# CITY OF SILOAM SPRINGS BOARD OF ADJUSTMENT

(Special-Called)

## AGENDA

# STAFF REPORT

# Variance Exhibit 2 of 2

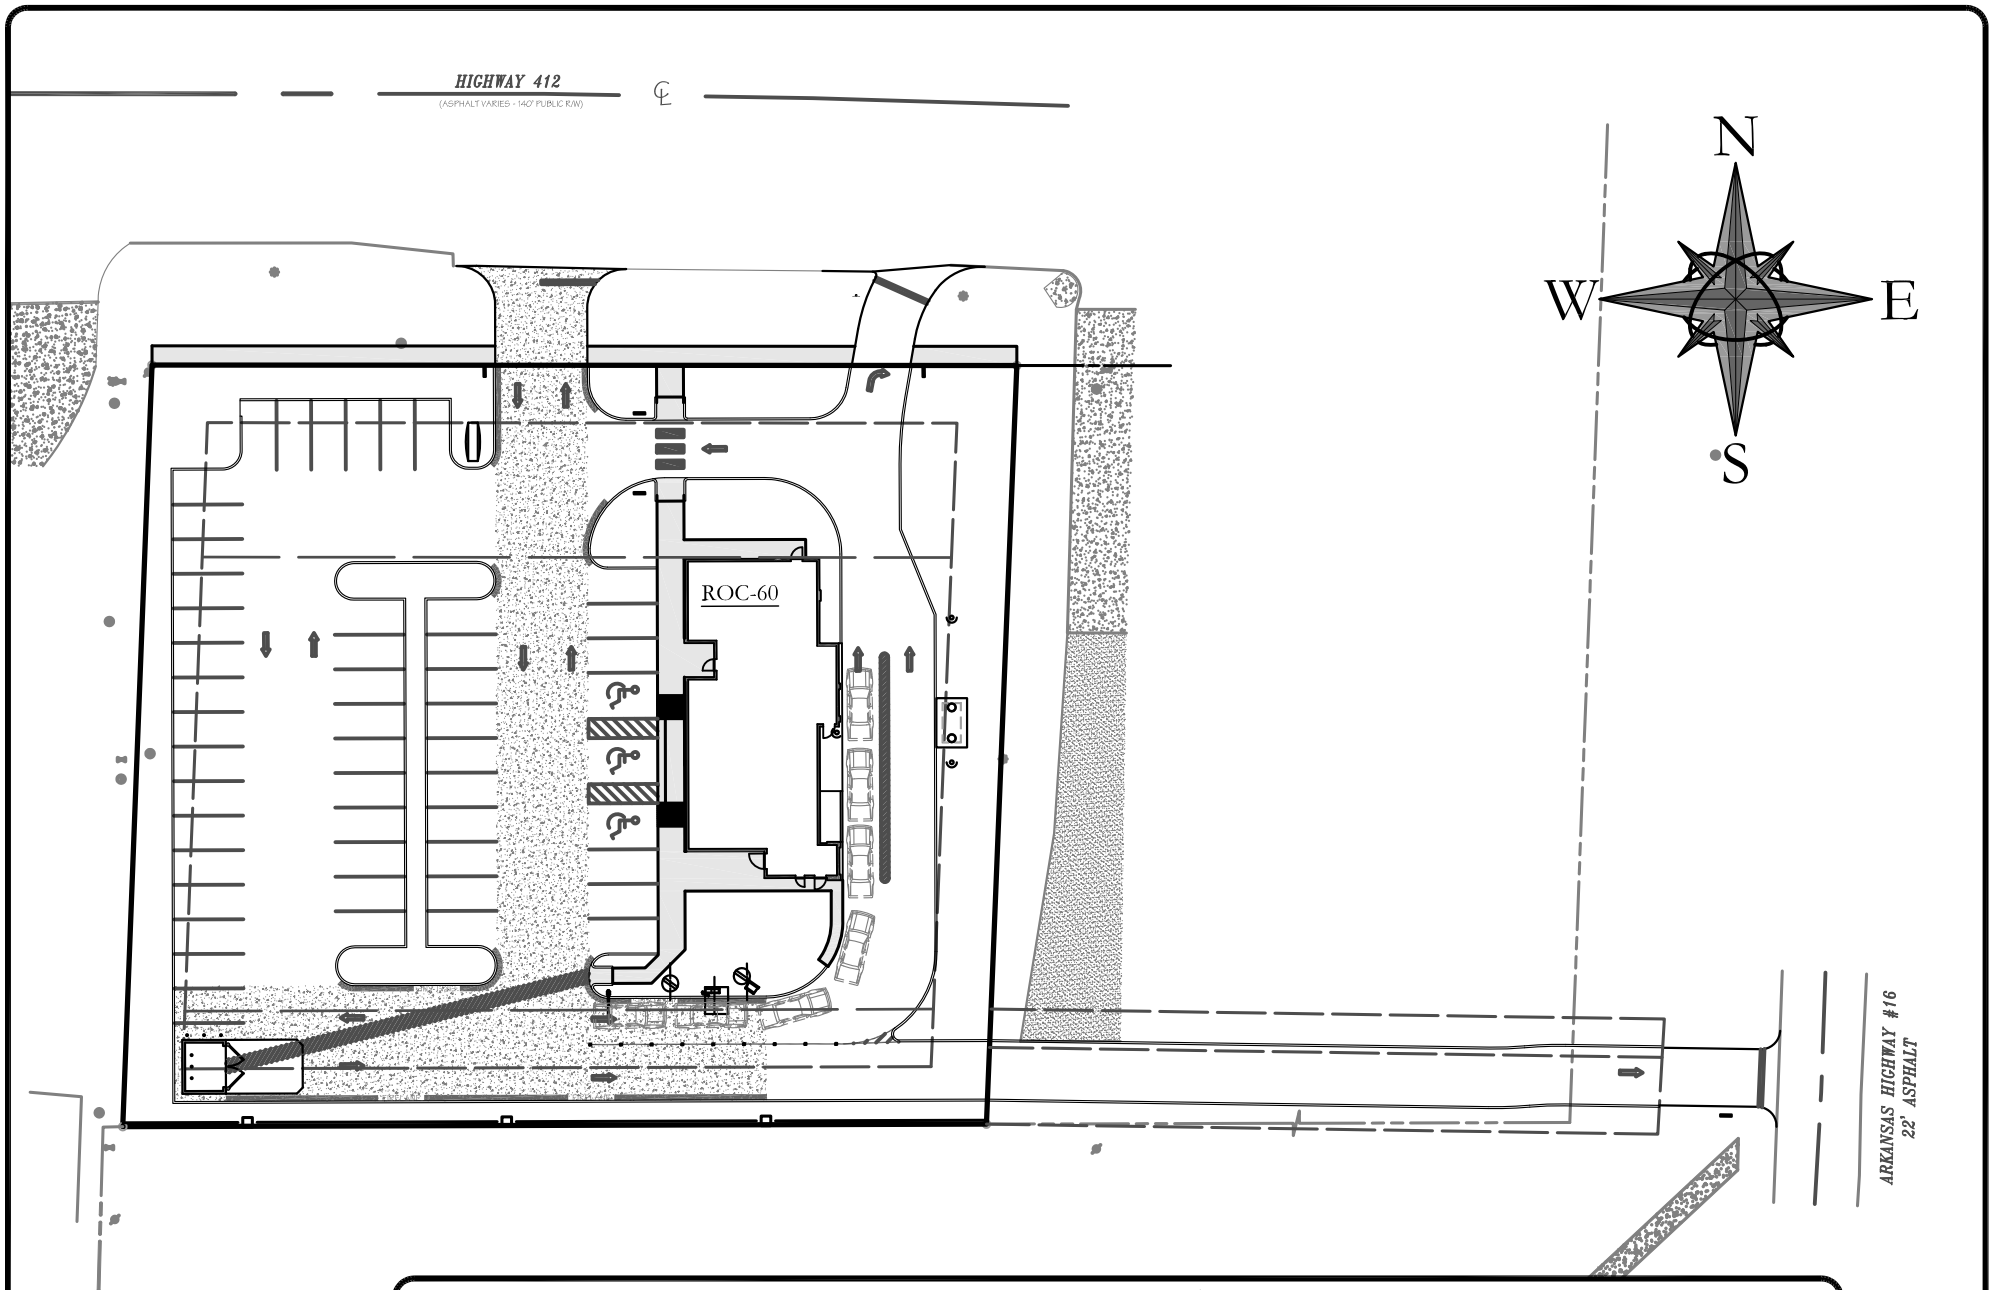
The second requested variance is related to an encroachment to the driveway spacing setback to Hwy. 412, which is also classified as an arterial street by the City's Master Street Plan. In this case, there is an interior drive and parking lane which are both encroaching within a 75 ft. prescribed setback. The interior drive ties the drive-thru lane back to the main drive. This drive is needed, as the second drive-thru drive is restricted as a right out only drive. So if a customer wanted to travel west on Hwy. 412 from the drive-thru lane, they would need to access the main drive in order to do this, or they would be forced to make a U-turn at the Hwy. 16 and Hwy. 412 intersection. It should be noted that for safety reasons, left turn movements will not be permitted from the northeastern (drive-thru) drive. The drive is design to prevent left turns. The lot is not deep enough to accommodate 75 feet of spacing from the Hwy. 412 right-of-way, to the needed connection from the drive-thru lane to the main entry/exit drive. See the attached exhibit site plan to visually see this connection. The same conditions also apply to the first parking lane for the parking lot. Even if the parking spaces on the north side of the lot were deleted, it would not remove the need for a parking lane to access the rear portion of the parking lot well within the 75 ft. setback buffer. Staff checked with the City Engineer and it is confirmed that both the internal drive and the parking lane will not likely cause vehicular stacking impacts on Hwy. 412 due to the overall site design for the facility.
